Final Report - Corrections Required **Application No. LUPL-25-0008**

Document Filename : 241010_BLR Village C Land Use Plan.pdf

BANNING LEWIS RANCH - VILLAGE C
LAND USE PLAN
COLORADO SPRINGS, CO
LAND USE PLAN

*Dwelling, Single-family Detached; Dwelling, Single-family Attached; Dwelling, Two-family (duplex).

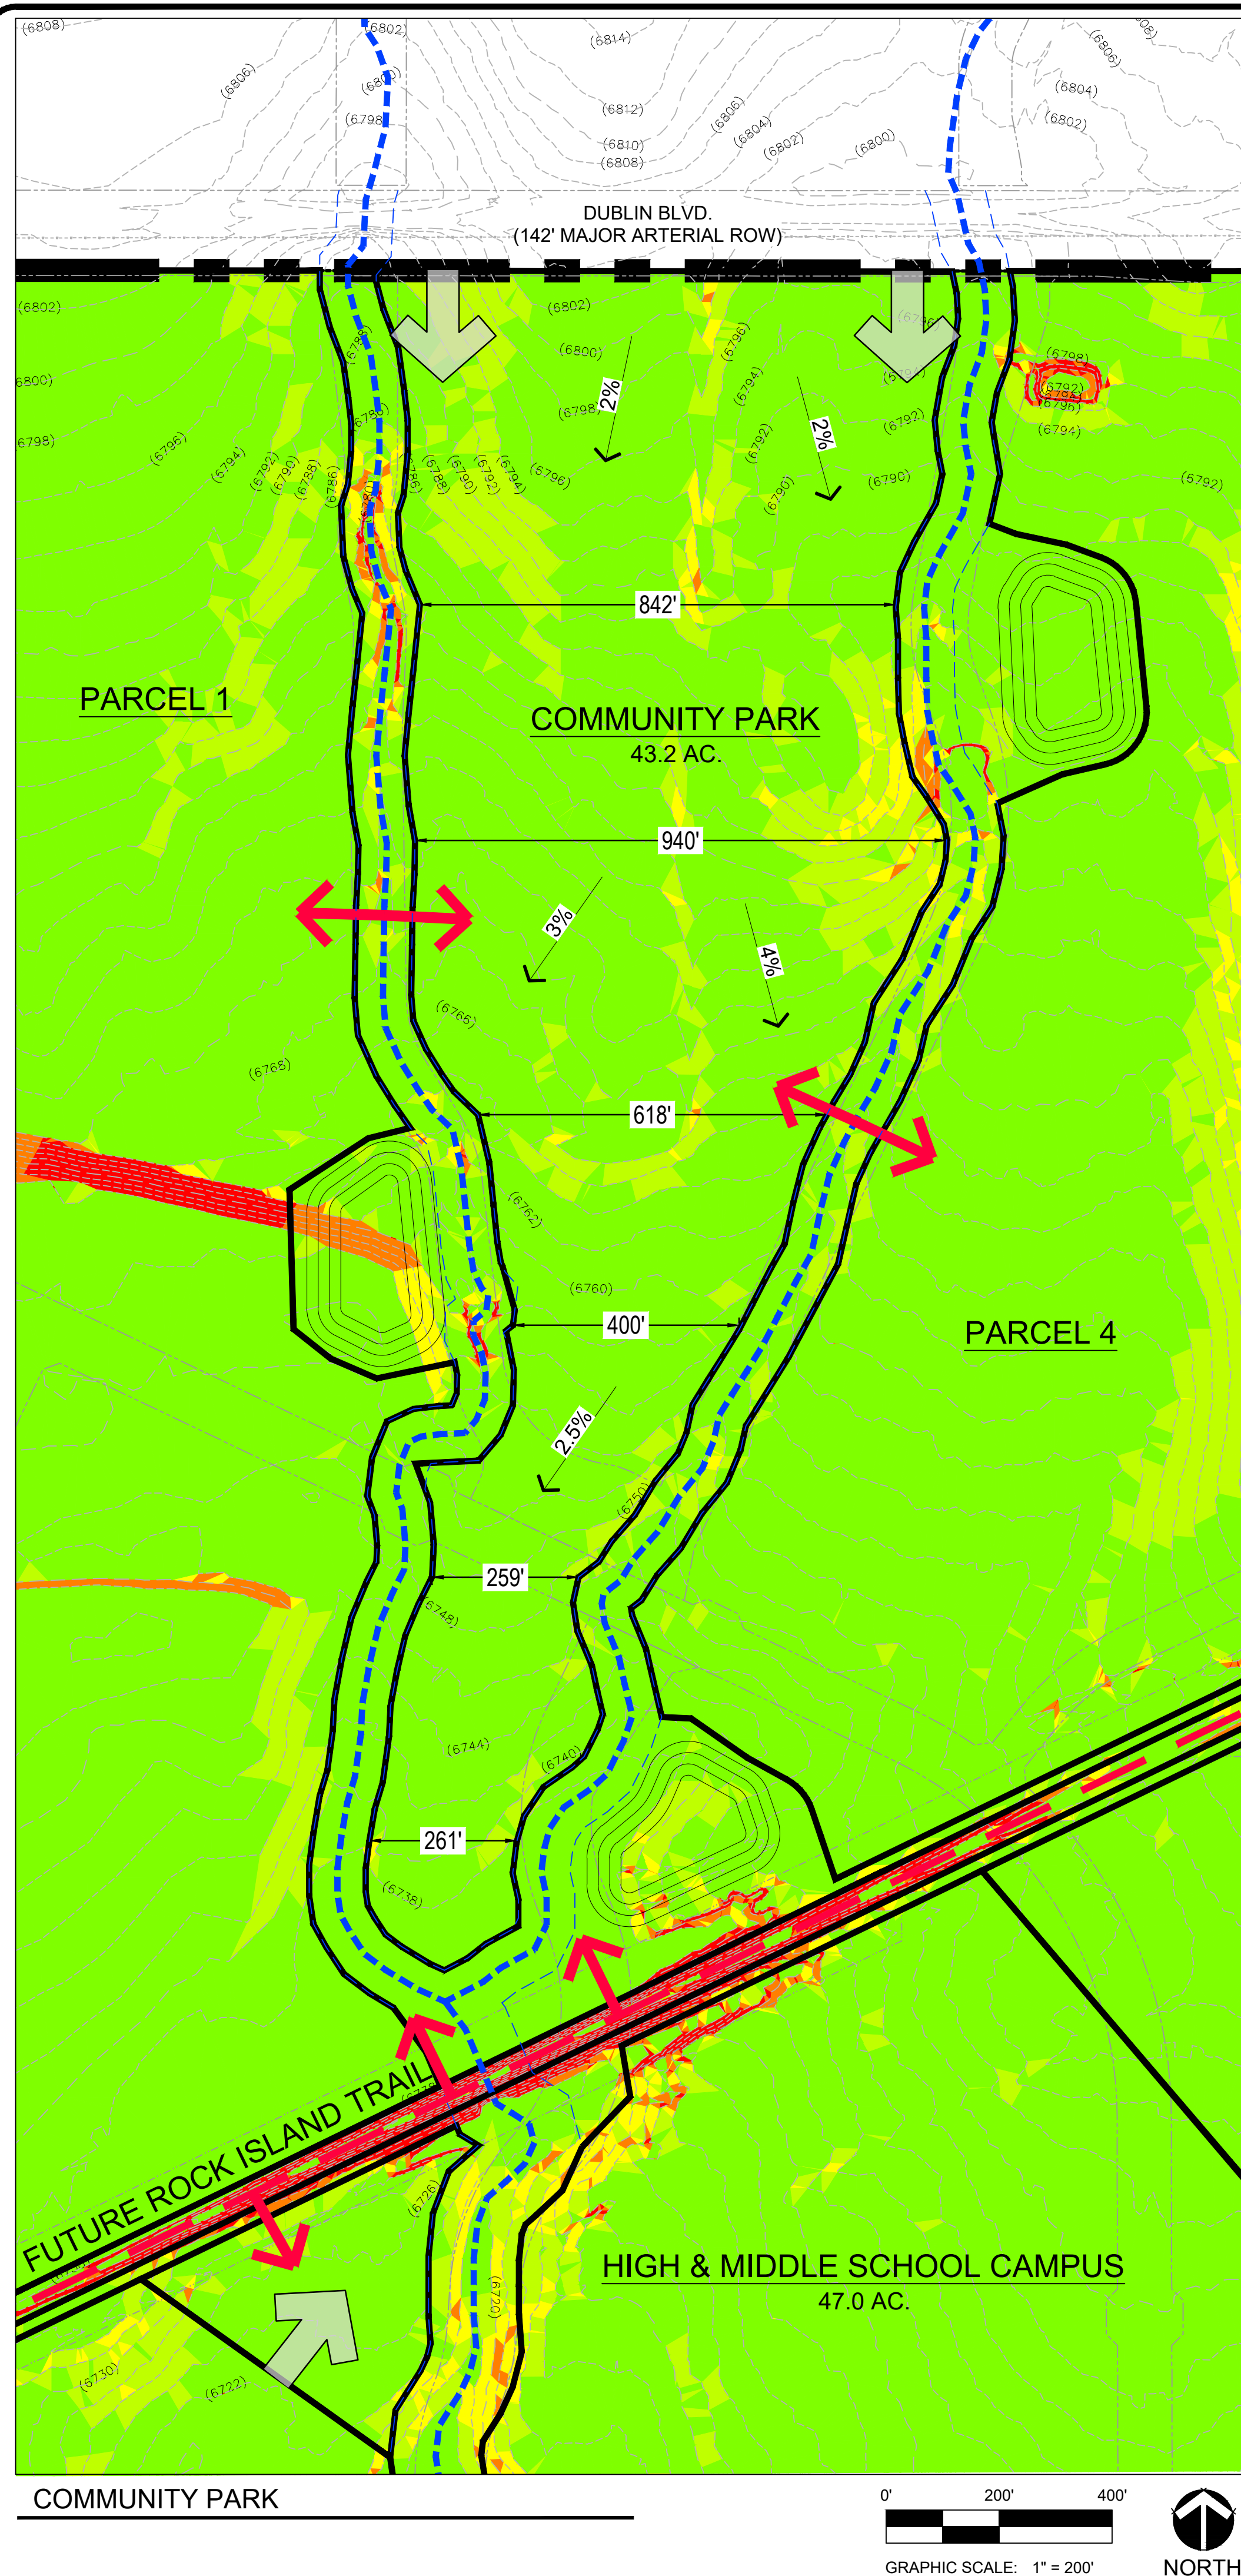
53	2	Tamara Baxter : Planning	Please use this on the coversheet as well.
54	2	Tamara Baxter : Planning	What does this residential encompass?
30	3	Caroline Miller : Planning	This graphic doesn't match the LUP Bubbles shown on page 2, park is not next to Public Safety.

Please use this on the coversheet as well.

BANNING LEWIS RANCH - VILLAGE C
 LAND USE PLAN
 COLORADO SPRINGS, CO
 BLR MASTER PLAN

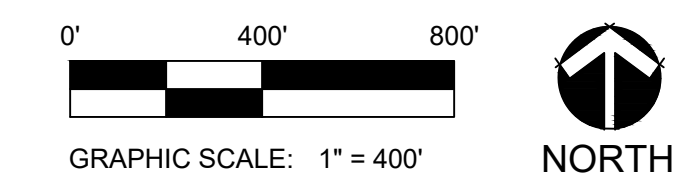
Refer to the date of this plan...ie what version.
